TECHNICAL BULLETIN

002

June 2013

Piston screws p.n. 1800.00, 1800.01, 1800.10, 1800.11, 1802.23 and 1802.27

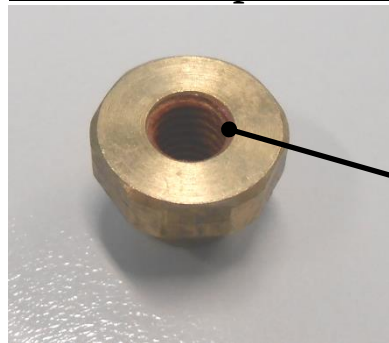
The screws and nuts have been changed to avoid unscrewing under severe vibrations. The locking adhesive is dry-to-touch and it is activated during assembly and cures to form a tough polymer that eliminates movement between the threads and provides a total seal. The new screws and nuts are interchangeable with the old ones and all part numbers did not change.

Viti fissaggio pistone codici 1800.00, 1800.01, 1800.10, 1800.11, 1802.23 and 1802.27

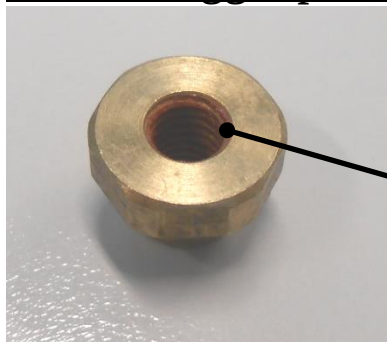
Le viti ed i dadi arresto pistone sono stati modificati per evitare svitamenti in presenza di forti vibrazioni.

L'adesivo bloccante preapplicato è formato da microcapsule che si frantumano in fase di assemblaggio rilasciando un attivatore che avvia il processo di polimerizzazione. Il prodotto polimerizzato si interpone tra le filettature riempiendo tutti gli interstizi bloccando e sigillando.

Le nuove viti ed i nuovi dadi sono intercambiabili e i codici non cambiano.
